**MEMORANDUM**

**REVIEW TYPE:** Preliminary Plan Review

**PROJECT NAME:** 10017 Locust Drive

**CASE #:** 120060730

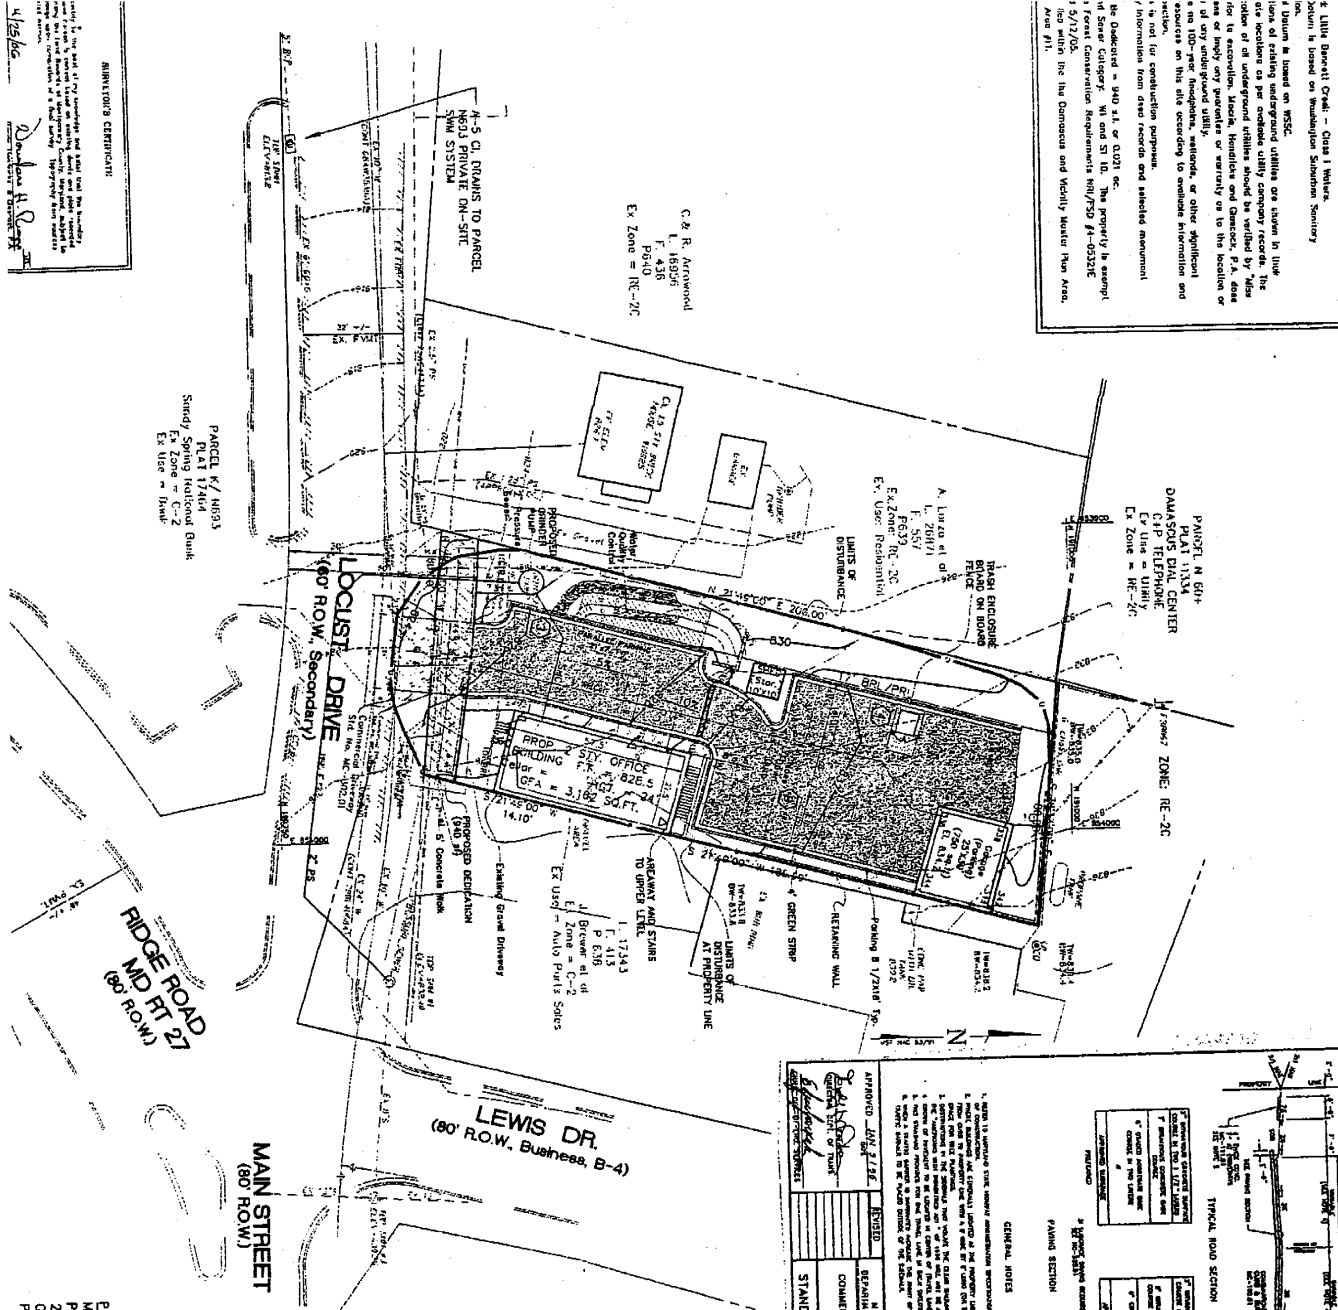
- On the Preliminary Plan, the trash enclosure is located such that a collection truck does not appear to be able to gain access.
- A note indicates that one handicapped space is required; it is not shown.
- The grading shown includes retaining walls at the property lines and five- to ten-percent slopes. Final grading should assure accessibility.
